SITE PLAN WITH WAIVERS FOR METCO LANDSCAPE

Maintenance Facility Site Plan
Amendment

METCO LANDSCAPE INC.
Maintenance Facility Site Plan Amendment
17603 E. 23rd Avenue Aurora, Colorado

AMENDMENT BLOCK

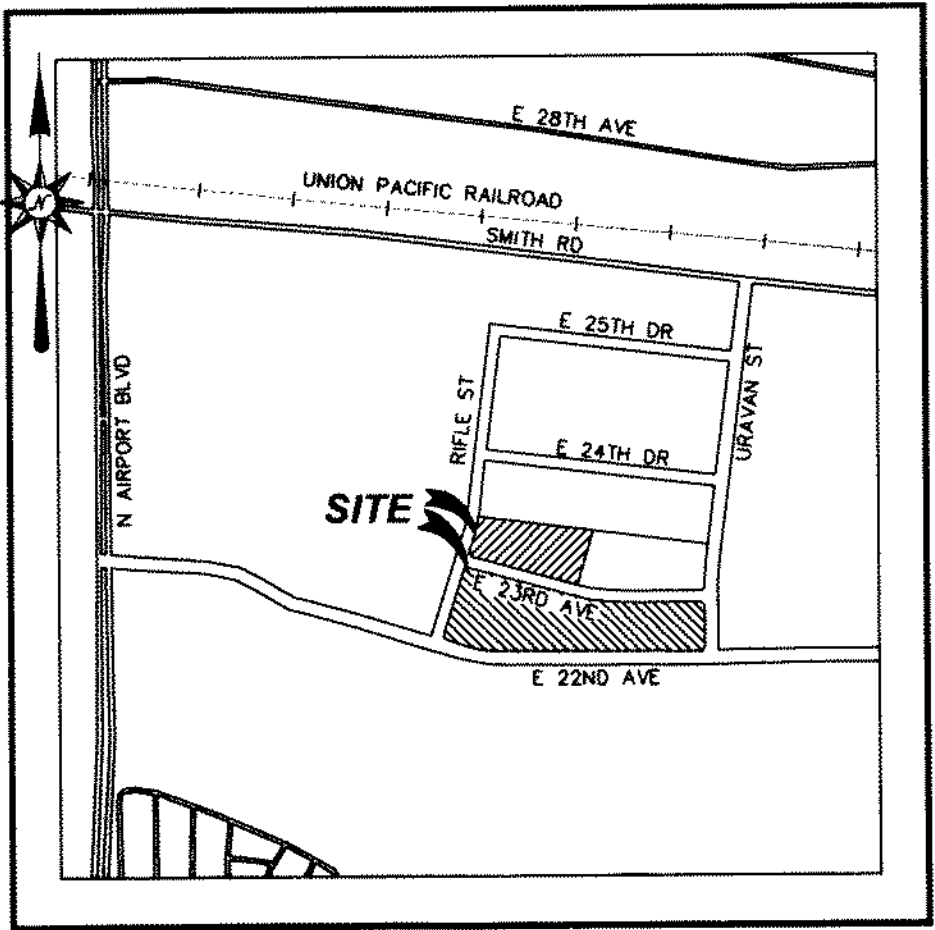
Please revise redline comment to read "Refer to updated data block on sheet 11" as the numbering of pages has changed.

"Comprised" is spelled incorrectly. Please change the note completely to read "7/26/2018 Addition of office building and storage facility on storage yard".

Sheet Number:
Amendment
11 OF 16

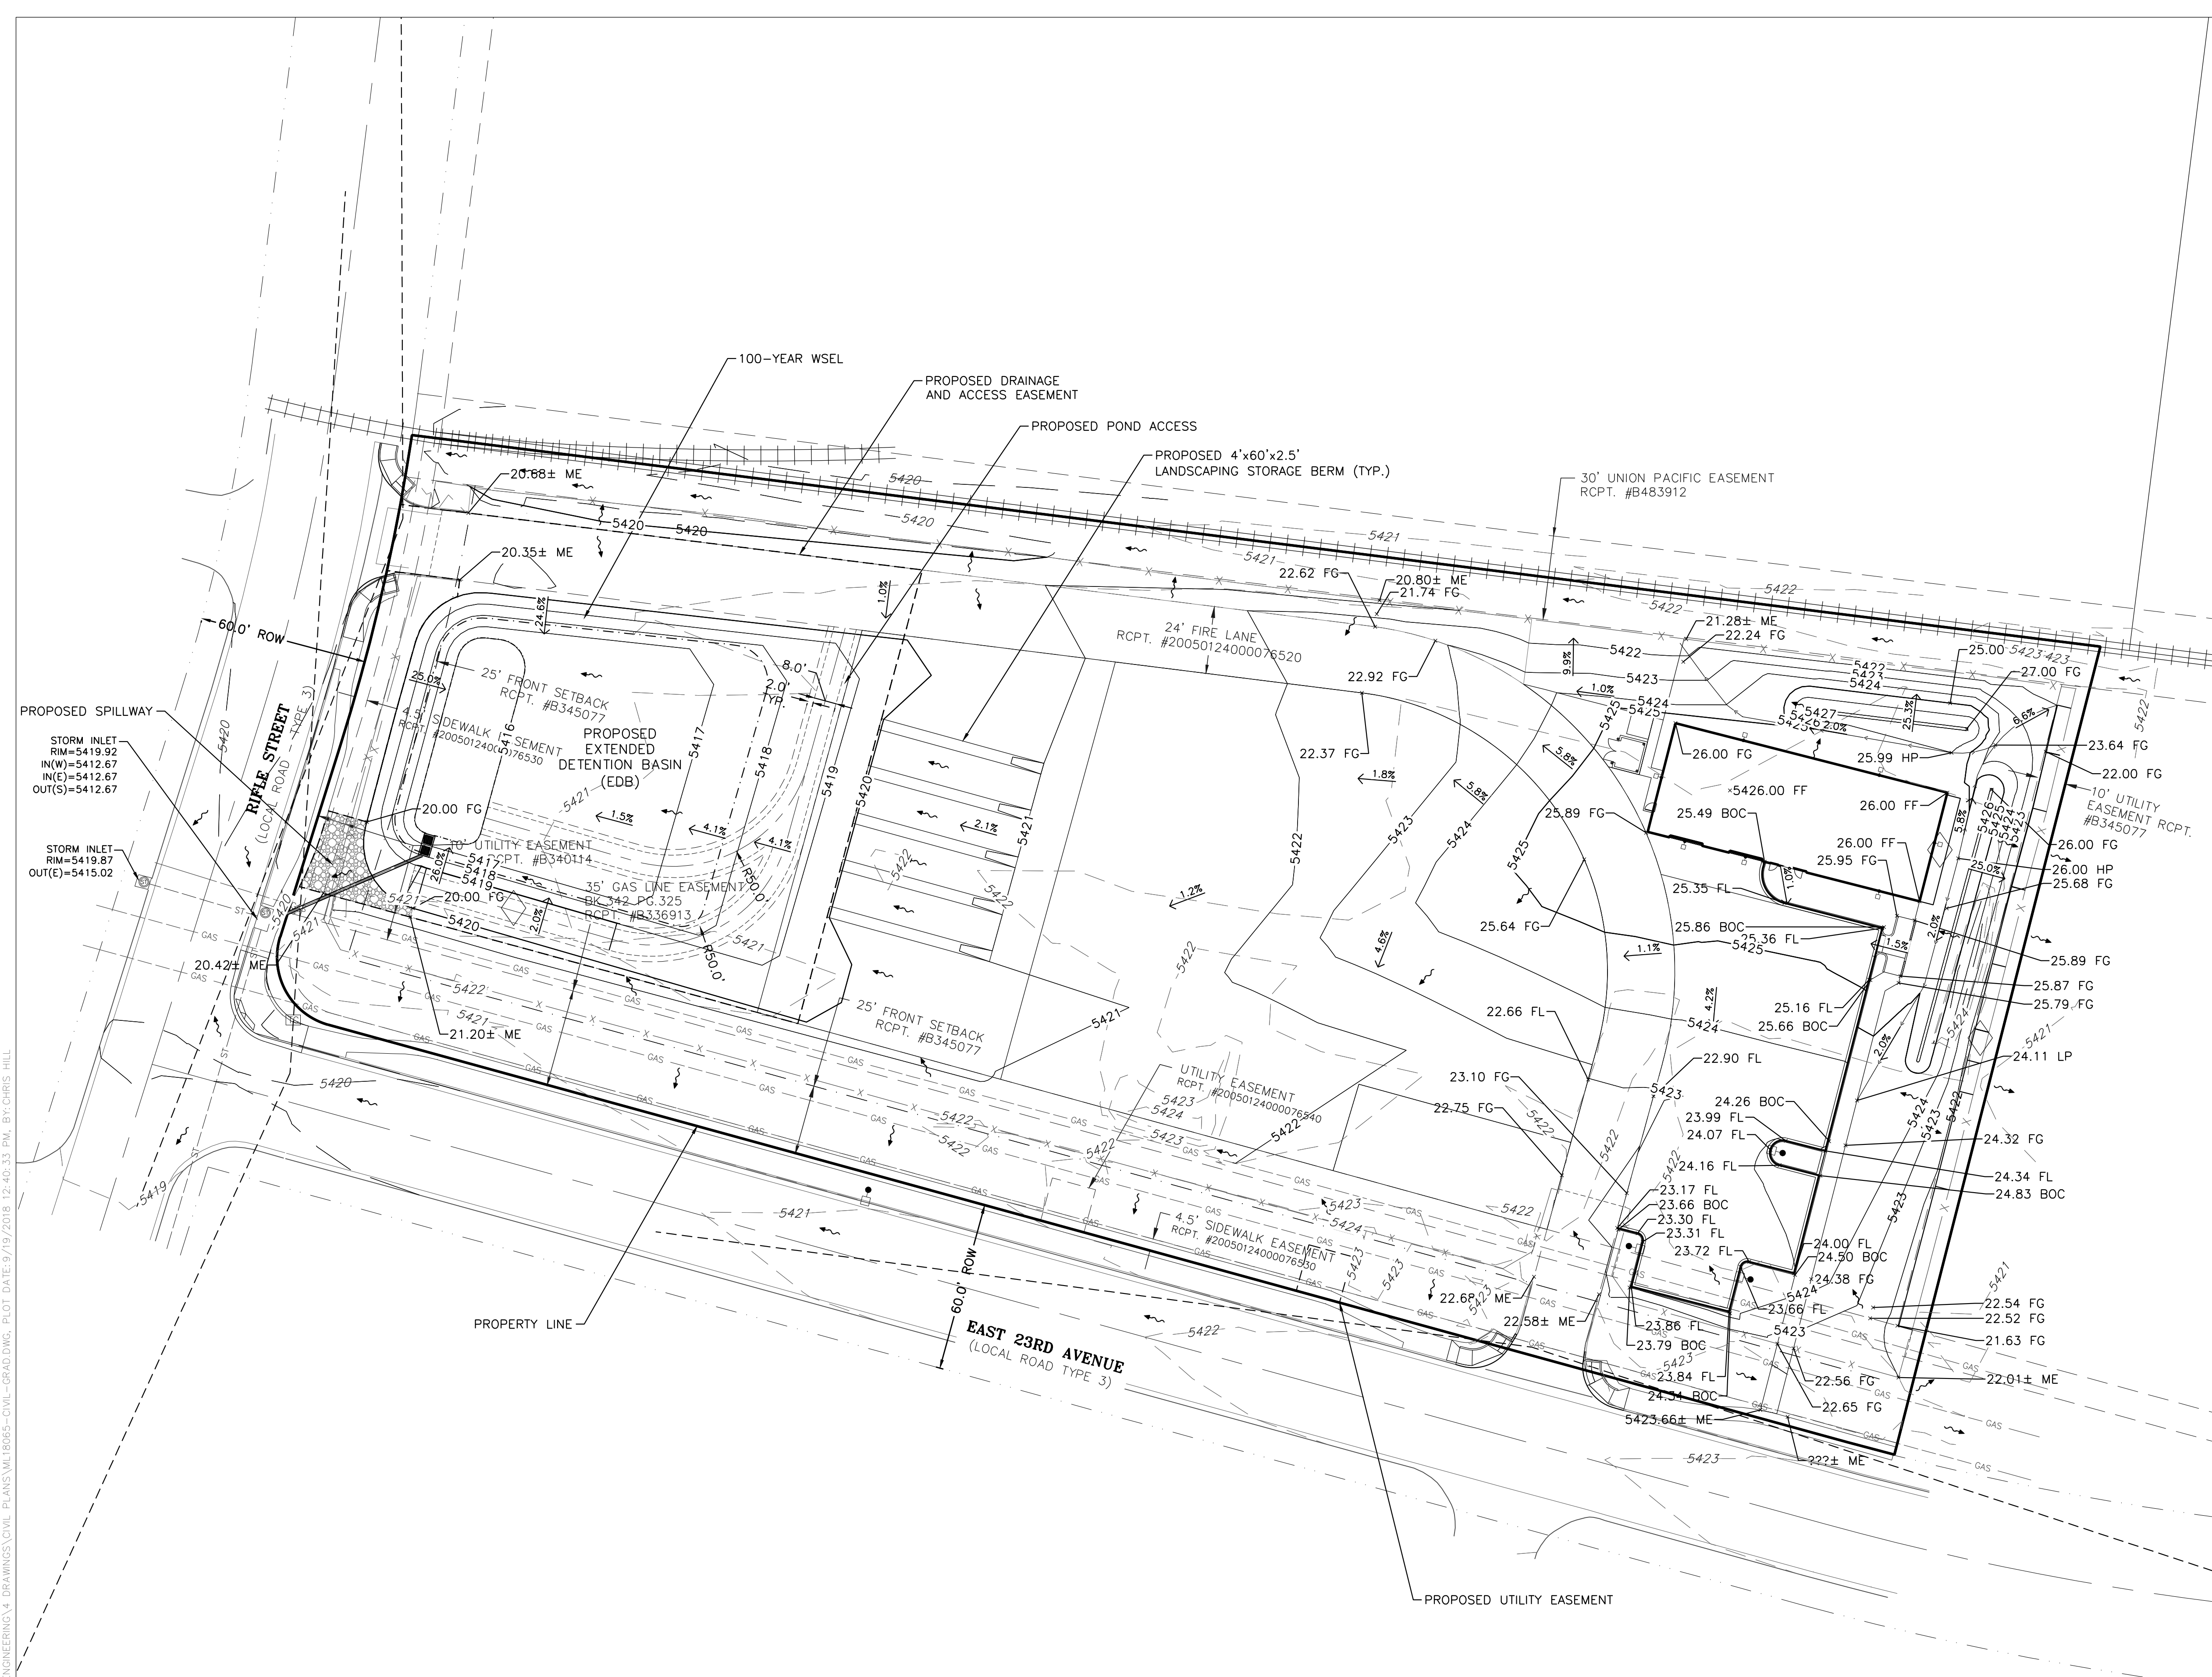
Please only reference this minor amendment once in the amendment border block. The date of the amendment should be consistent throughout the pages. Please use 7/26 as it has been referenced as the amendment date on all previous pages. Do not include revision dates and submissions within this amendment process. Only one date should be referenced. Delete the 9/20 submittal line from this block.

Maintenance Facility Site Plan Amendment
Sheet Title:
GRADING PLAN
Sheet Number:
Amendment
12 OF 16

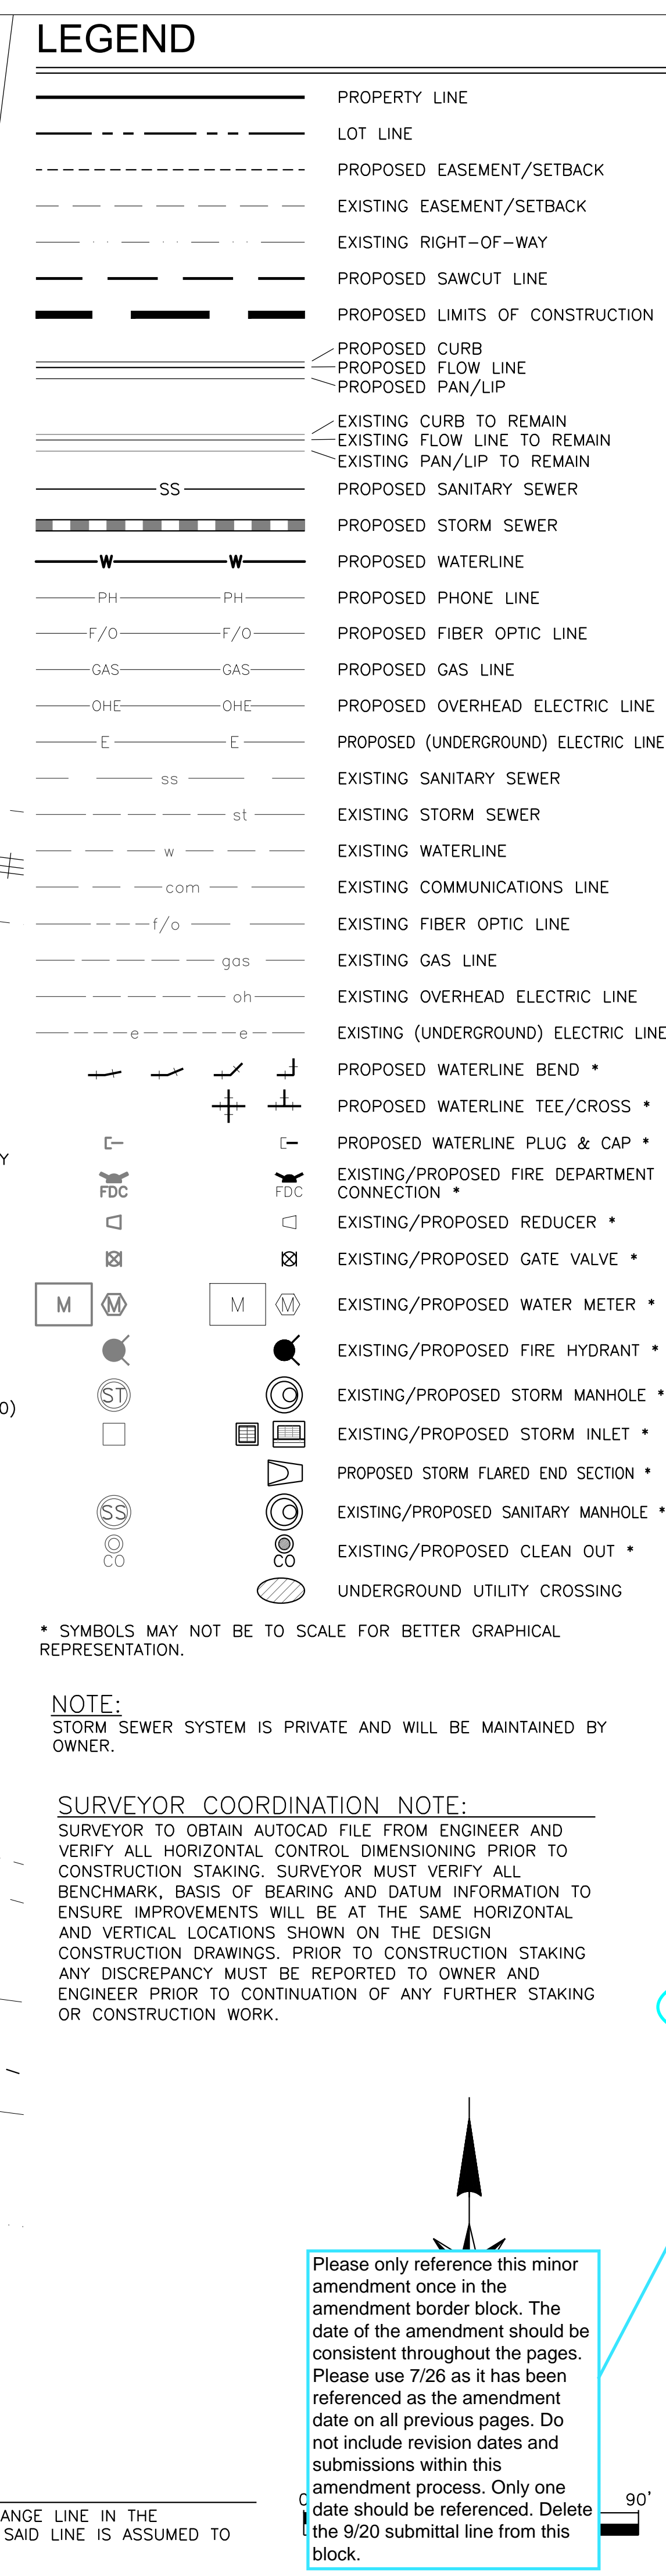
Please only reference this minor amendment once in the amendment border block. The date of the amendment should be consistent throughout the pages. Please use 7/26 as it has been referenced as the amendment date on all previous pages. Do not include revision dates and submissions within this amendment process. Only one date should be referenced. Delete the 9/20 submittal line from this block.
